**GENERAL HOSPITAL DEVICES BRANCH
INTERCENTER CONSULT MEMORANDUM**

Subject: Consult for BLA125612/ICC1600759

Applicant	Octapharma Pharmazeutika
Indication for Use	For the treatment of acute bleeding episodes (b) (4) in adult and pediatric patients with congenital fibrinogen deficiency, including afibrinogenemia and hypofibrinogenemia
Drug / Biologic Constituent	Human Fibrinogen/Fibryna
Device Constituent	Octajet transfer device Filter (Cleared under (b) (4))

Approval of the device constituents (Octajet and (b) (4) Filter) for the combination product Fibryna

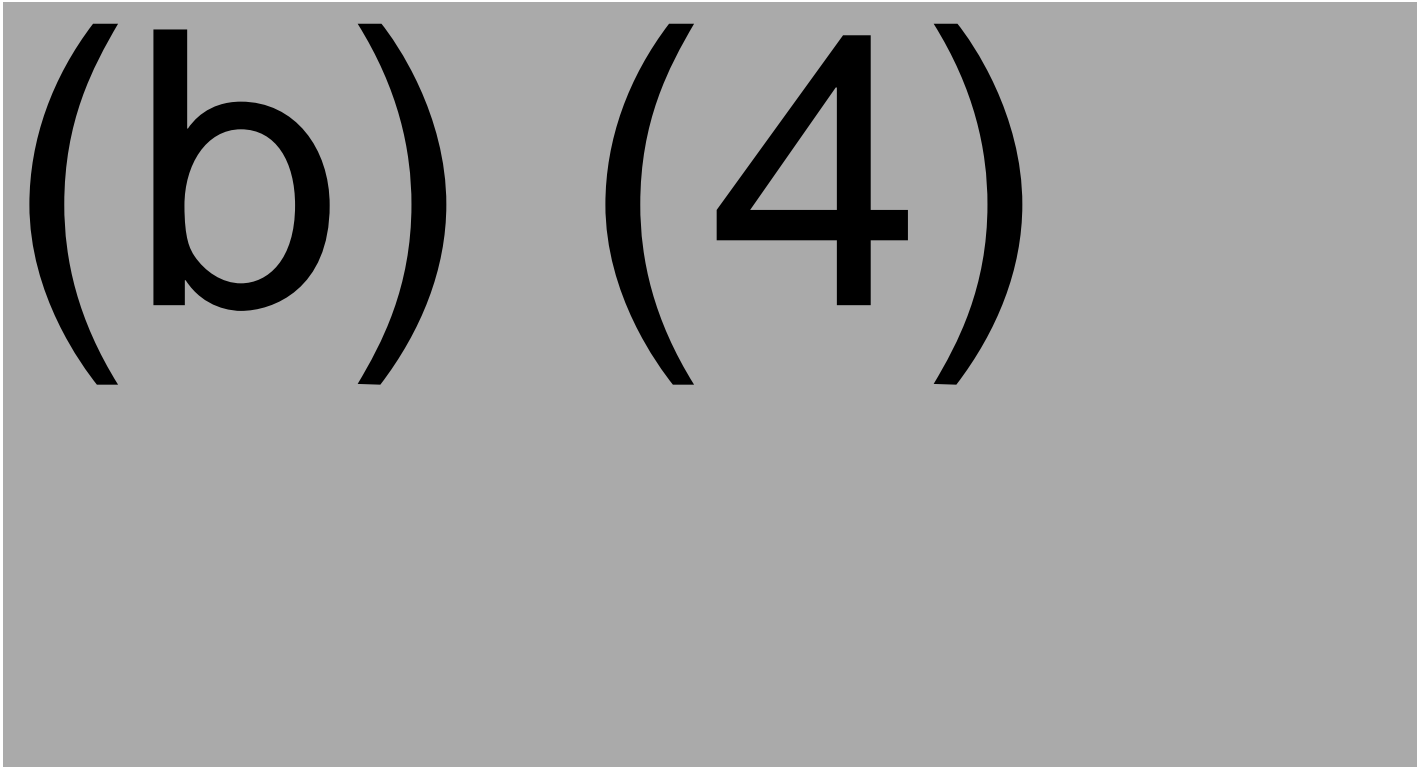
You have provided attachment force testing which compares the Octajet to the (b) (4) device and meets your acceptance criteria of an attachment force of (b) (4). You have not performed this testing with your drug vial. We recommend that your performance testing is completed with all constituents of the combination product to ensure that your device performs as expected when used as a system. Please provide testing that supports that the attachment force when used with your drug vial still meets your criteria of (b) (4).

Sponsor response:

The manufacturer/ supplier of the transfer device Octajet, (b) (4), committed to perform additional performance testing. The following tests are going to be performed:
